ENGINEERINGUPDATE

NO:	SW - 118
DATE:	March 2017

PRODUCT: D2D and D2T – Door Switch TYPE: Modification – UL Standard and Marking Change

D2D and D2T Door Switch - UL Standard and Marking Change In accordance to UL Standard transition from UL1054 to UL61058-1

D2D-2000 Model Detail of Changes - Marking:

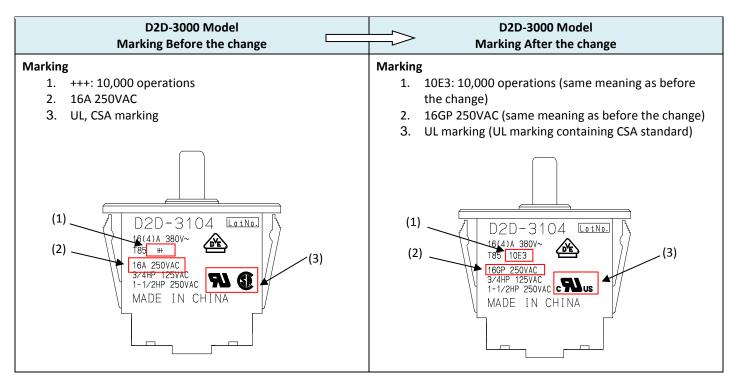
D2D-2000 Model Marking Before the change	D2D-2000 Model Marking After the change
Marking 1. 1E4: 10,000 operations 2. 10A 250VAC 3. UL, CSA marking	 Marking 1. 10E3: 10,000 operations (same meaning as before the change) 2. 10GP 250VAC (same meaning as before the change) 3. UL marking (UL marking containing CSA standard)
(1) (2) (1) (2) (2) (1) (2) (2) (2) (3) (3) (3) (3) (3) (3) (1) (1) (2) (3) (3) (3) (3) (1) (1) (2) (3) (1) (1) (2) (2) (1) (1) (2) (2) (2) (2) (2) (2) (2) (2	(2) (1) (2) (1) (2) (1) (2) (1) (2) (1) (2) (1) (2) (1) (2) (1) (2) (1) (2) (1) (2) (1) (2) (2) (2) (2) (2) (2) (2) (2
